**Matilija Dam Ecosystem Restoration Project
Fine Sediment Management Study Group**

Questionnaire for March 30 meeting

Name & Affiliation: Matilija Coalition

Additional Comments on Matilija Dam Final Design – Slurry Disposal

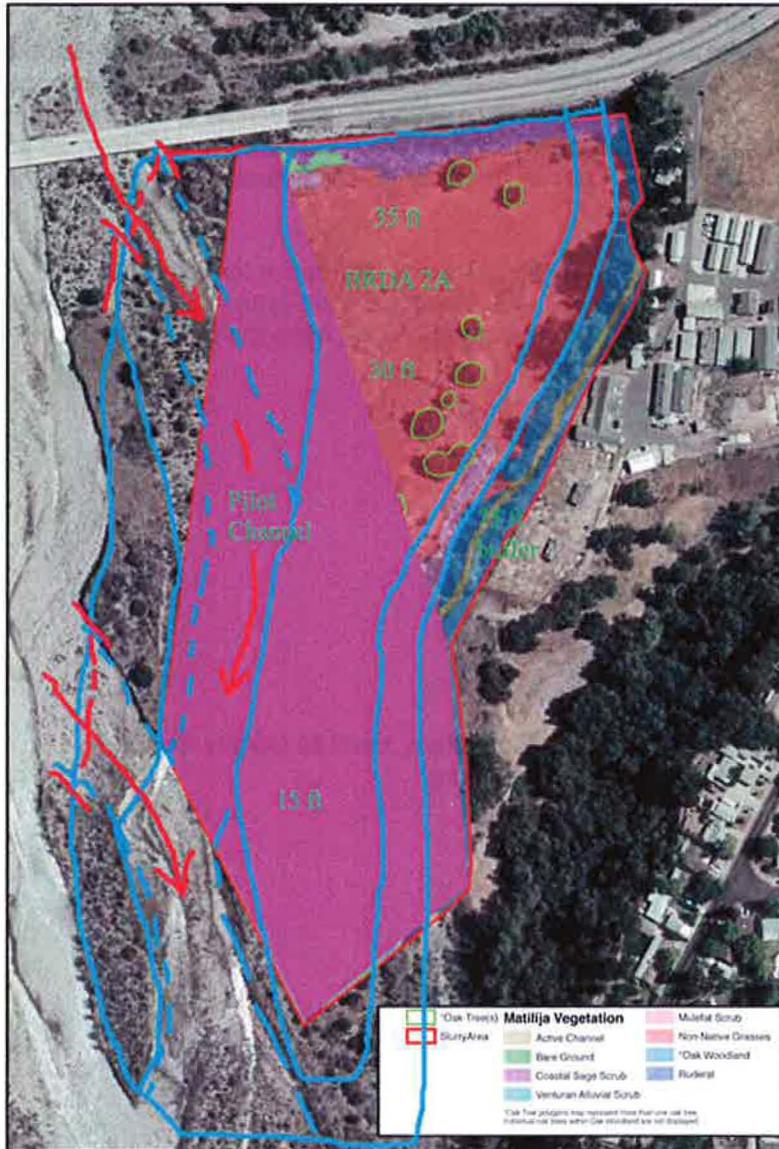
BRDA 1 would provide *temporary storage of 750 AF of fine sediments*, intended to be completely transported downstream following a series of flood events. This is accomplished by managing a pilot channel that follows the alignment of the existing river side-channel. This pilot channel will direct high flows from the mainstem channel through the disposal area to initiate and actively erode the sediments. This is controlled with a temporary levee (or containment dyke) that includes a 'flushing weir' at the upstream end of the pilot channel.

The footprint outlined in blue in this figure includes expansion of the disposal area onto the floodplain terrace to the east of the active channel. This would provide greater insurance that flows would not enter behind the disposal area and threaten downstream infrastructure. This area will also provide a staging area and additional capacity to account for the pilot channel, which would necessarily be an area of lower fill depth.

Adaptive management of this area would include monitoring the containment dyke and erosion to ensure release of fine sediments downstream occurs during predetermined flow events. The weir entry is designed to direct flows into the pilot channel during such events to facilitate removal of stored sediments. In this manner a large flood event may effectively remove a large portion of the temporary sediments (highlighted in blue.) In the dry season following such an event the remaining sediment could be re-distributed within this erosion zone in preparation for the next flood. *Eventually this area would return to natural floodplain with little evidence of the slurry activities.*

The BRDA 2 disposal area may store 600 AF of sediment (BRDA 2 with BRDA 2A superimposed.) BRDA 2A is a 15-acre sub-area in which the total deposition would average 30 ft deep. The erodable area (pink) includes a pilot channel designed in the same manner as BRDA 1. The fill is deepest adjacent to Baldwin Rd, which could be used as a containment dyke. The east edge of the disposal area will taper down to leave a 75 ft buffer/channel from the toe of the bluff to accommodate existing flows and maintain the mature sycamore and oak trees. The disposal area is expanded slightly to the west and south to provide additional capacity to account for the buffer zone and pilot channel.

Adaptive management would be used to optimize the erosion of temporary storage areas as described for BRDA1. The upland terrace would be revegetated, but the pilot channel and erosion zone would require minimal restoration. *In the future, the BRDA 2A area may be all that remains as a permanent feature of the landscape, so full restoration efforts need only be focused on this 15-acre area.*
